### 2 Type of change

Change country of origin

Product Change Notification					Fusedrawer 2 change country of origin		
owner	creation date	release date	released by	change order no	rev	page	D10-046-583
sariogar	22.06.2020	23.06.2020	muehlema	2020156	A	1 of 1

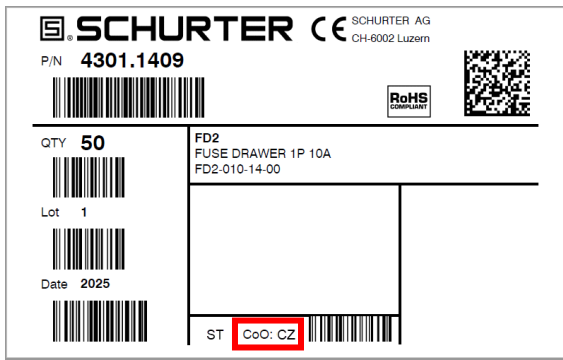
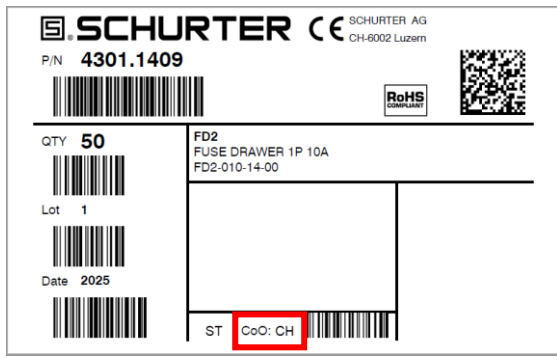
Change country of origin from Czechia (CZ) to Switzerland (CH)
